Item ID: D2580-1 Accept ***N900040100*** Setup Start ***NS1***
 Revision ID: Stop ***NS2***
 Item Name: 205 Bent Tube
 Start Date: 3/12/13 Start Qty: 2.00 ***2*** Cust Item ID:
 Required Date: 3/12/13 Req'd Qty: 2.00 ***2*** Customer:
 Reference:

DRAWING NO. D2580	TITLE 205 SKIDTUBE ASSEMBLY	REV. E	DART AEROSPACE LTD ENGINEERING ORDER		D.E.O. NO. D2580-E-1	SHEET NO. SHEET 1 OF 1	SCALE NTS
DRAWN <i>UP</i>	CHECKED <i>ASS</i>	MFG. APPR. <i>EC</i>	APPROVED <i>[Signature]</i>		DE APPR. <i>[Signature]</i>		
DATE 11.12.13	DATE 11.12.13	DATE 11.12.13	DATE 11.12.13		DATE 11.12.13

PURPOSE:

CHANGE ALL C'BORED WELDED CROSSBOLT SPACERS TO SWAGED SPACERS

D5-2
SECTION B-B
SCALE 5X

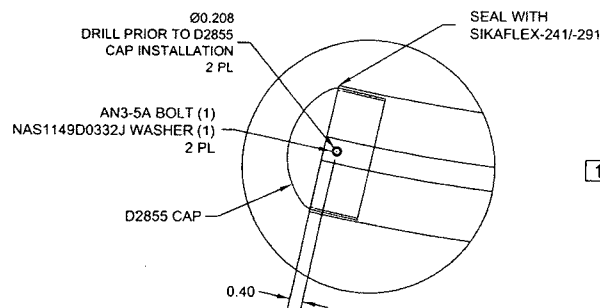
- AFTER DRILLING AND BENDING ASSEMBLY
PERFORM THE FOLLOWING FOR Ø0.508 HOLES ONLY:
1. CHAMFER HOLE 0.050 X 45°
 2. INSERT D2579 SPACER (20 PLACES)
 3. WELD INTO PLACE AND GRIND FLUSH
 4. C'BORE D2579 SPACER TO Ø0.437 X 1.00 DEEP

SECTION B-B, F-F, I-I
NOT TO SCALE

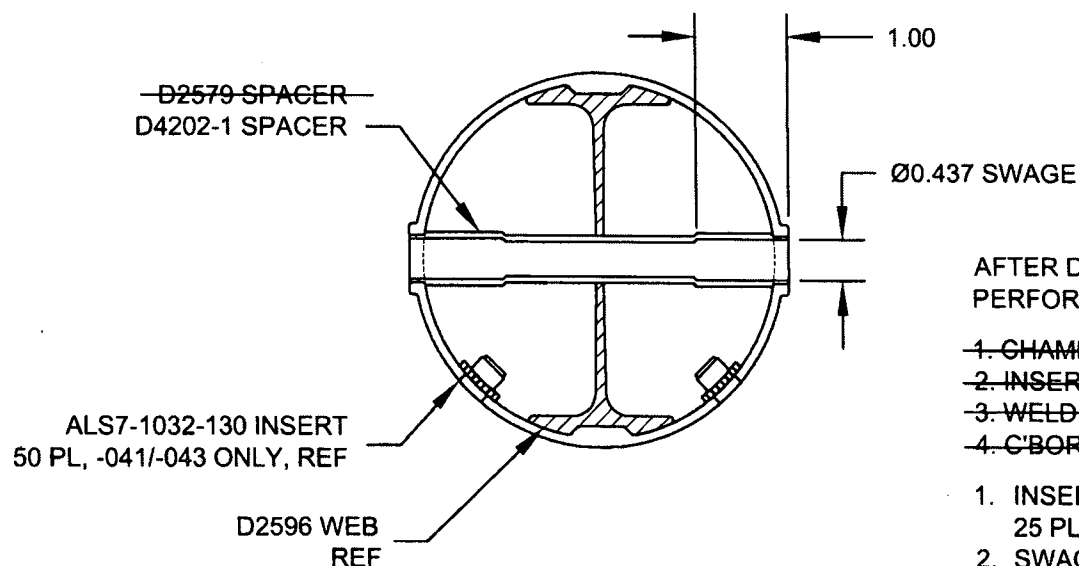
SECTION B-B, SECTION F-F, & SECTION I-I ARE AMENDED AS FOLLOWS
FOR ALL HOLES THAT WERE ORIGINALLY C'BORED:

*** FOR -045 SKIDTUBE ONLY:**

WELD 4X D2579 SPACERS PER DWG
IN LOCATIONS MARKED "NO C'BORE".
REF SHEET 4 OF DWG.

AFTER DRILLING AND BENDING ASSEMBLY
PERFORM THE FOLLOWING FOR Ø0.508 HOLES ONLY:

1. CHAMFER HOLE 0.050 X 45°
2. INSERT ~~D2579 SPACER (20 PLACES)~~
3. WELD INTO PLACE AND GRIND FLUSH
4. C'BORE ~~D2579 SPACER TO Ø0.437 X 1.00 DEEP~~

1. INSERT D4202-1 SPACER, 20 PL (-041) OR 20 PL (-045) OR 25 PL (-047)
2. SWAGE TO Ø0.437 X 1.00 DEEP PER QSI 002
3. TRIM / GRIND FLUSH PER QSI 002
